Item C-13 Questions from Commissioner Shaw with Proposed Motions- Amended 4/22/2019**Building Forms on Single Family Zoned Lots**

C-13 Shaw – Affordability Amendments Ordinance**Attachment 1****§ 25-2-560 - MULTIFAMILY RESIDENCE LIMITED DENSITY (MF-1) DISTRICT REGULATIONS.**

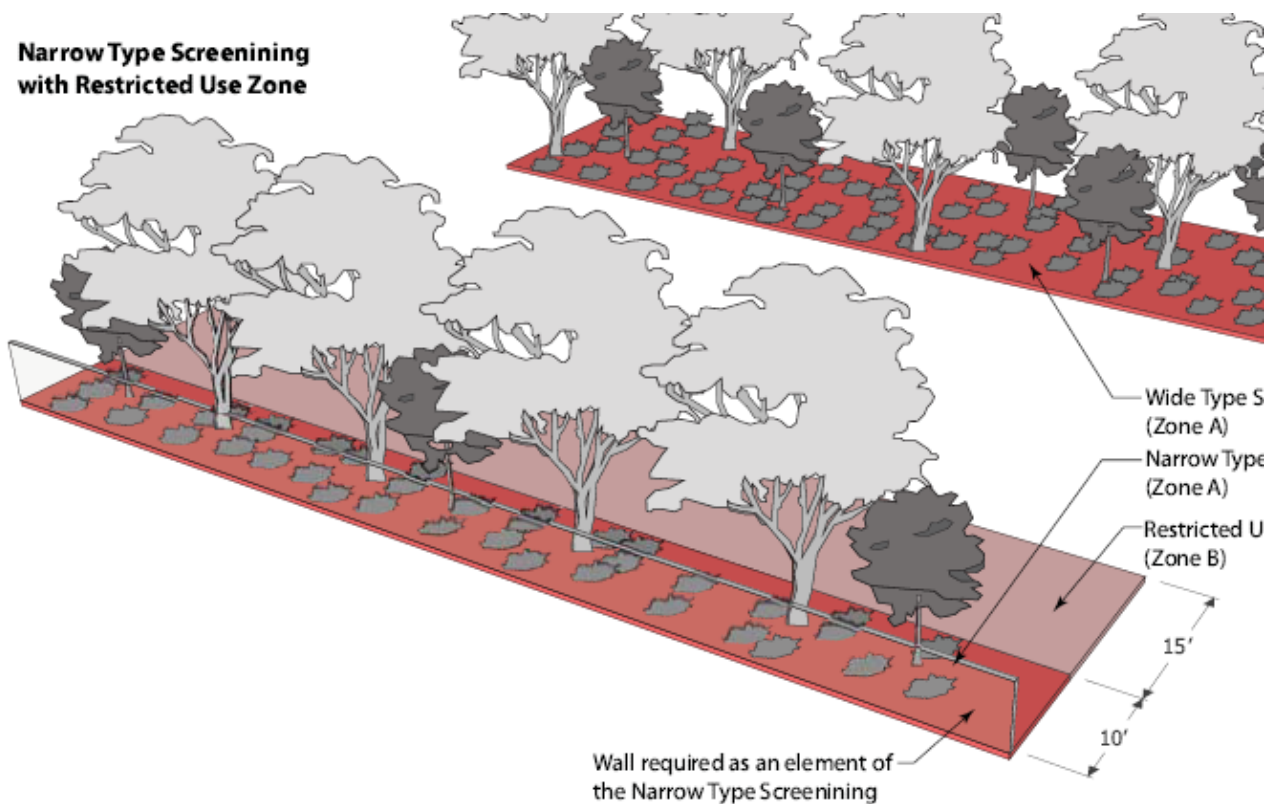
- 1) Qualifying Developments that accept compatibility waivers for height and setbacks, development shall include following screening requirements:*

[Reference ERC compatibility design requirements 4.2.4 (D) for screening with narrow 10' landscape buffer.]

a. Location and Width of Zone A Screening Zone

- i. **Location:** Immediately abutting the property line of the triggering property located between the triggering property and Zone B.
- ii. **Width:** The Screening Zone can be one of two types, Wide or Narrow (See Figure 4-3). The width of Zone A varies depending on which type of Screening Zone is applied.

b. Narrow Type (to be used in conjunction with Use Restricted Zone)

- i. **Width:** Varies with a minimum width of 10 feet.
- ii. **Installation Requirements:**
 - A wall six feet in height;
 - One shade tree per 25 lineal feet;
 - Three understory trees per 100 lineal feet; and
 - 40 shrubs per 100 lineal feet.
